GSI-191, “Assessment of Debris Accumulation on PWR Sump Performance”

Advisory Committee on Reactor Safeguards

September 29, 2010

September 17, 2010, ACRS Letter

Schematic of Long-term Recirculation System

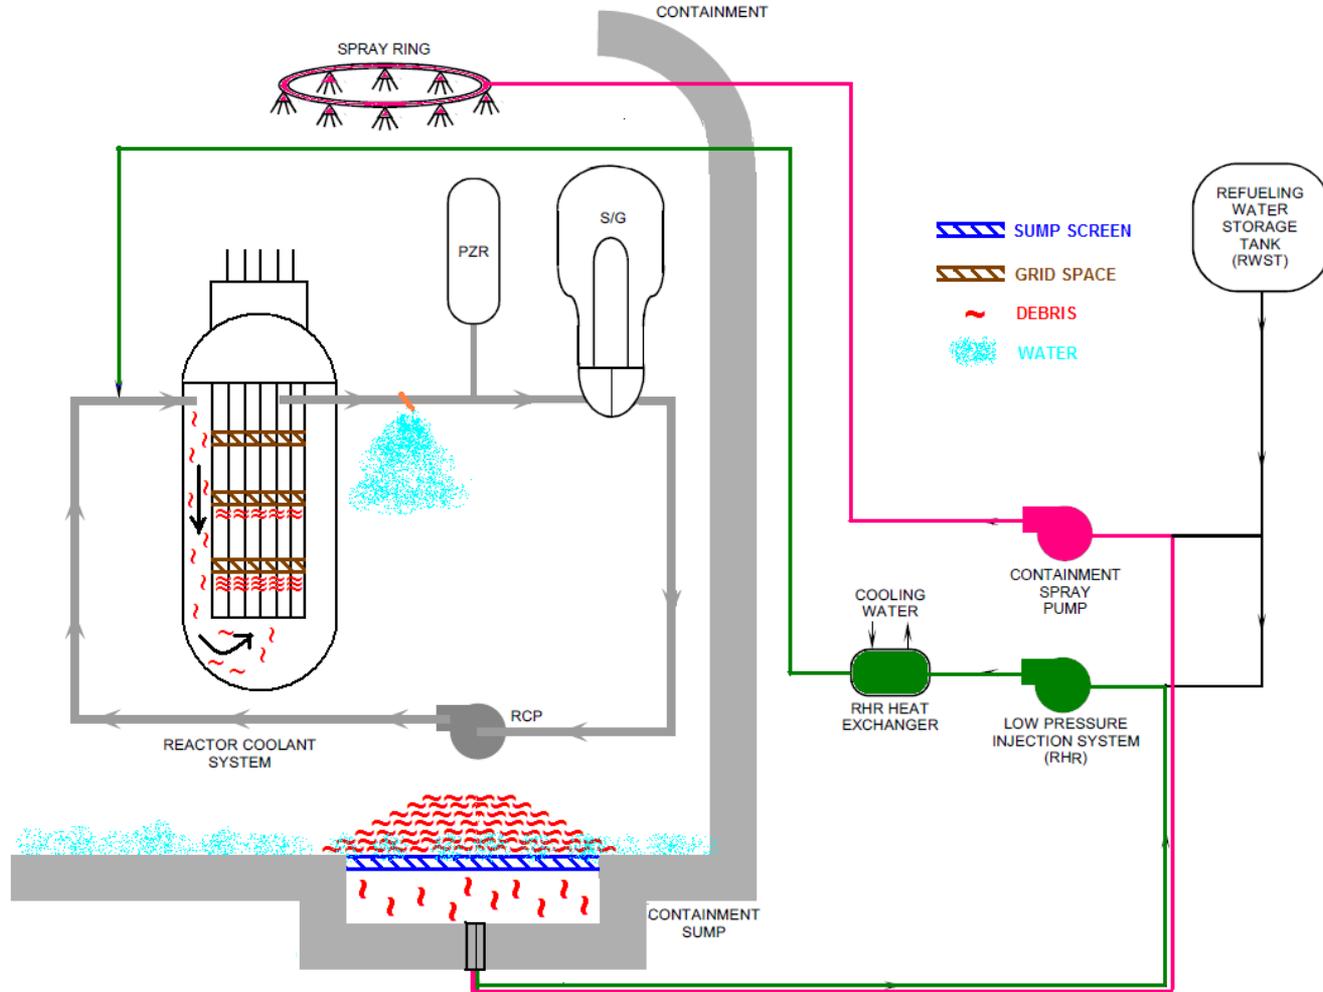
In-vessel effects should not be separated into another generic issue

- ***Sump screens and core act in concert to filter debris in the recirculation system***
- ***Large area screens may allow more flow but may allow more debris to pass through to the core***
- ***In-vessel blockage increases with increased debris loads that may pass through the screens***
